<b>Subject:</b> <b>POWER RETRACTABLE HARDTOP - FRONT ROOF PANEL CONTACTS DECK PANEL</b>	<b>Bulletin No:</b> 09-035/07
	<b>Last Issued:</b> 10/1/2007

2007 MX-5 vehicles with VINs lower than JM1 NC\*\*\*\* \*\* 132933 (built before December 11, 2006)

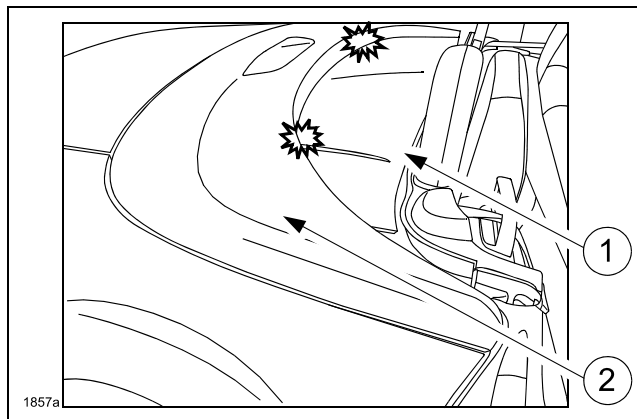
On some power retractable hard top vehicles, the front panel (1) of the hard top may contact with the deck panel (2) when in the open position. This condition may be the result of improper engagement of the roof hook, due to the roof hook cable coming loose from the cable case.

Inspect the roof hook cable for disengagement from the cable case; this case is located behind the access panel, behind the driver's seat. If it is found to be disengaged, replaced the cable case using the following procedures.

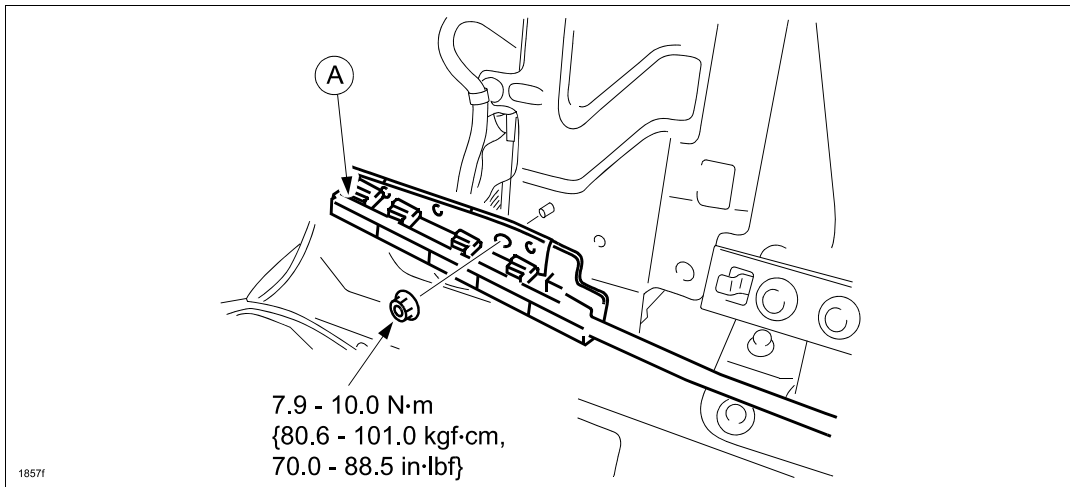
- Remove the cable case (A) from the vehicle and replace with a modified one.

Part Number	Description	Qty.	Notes
NE52-R1-9HX	Cable Case Ass'y	1	---
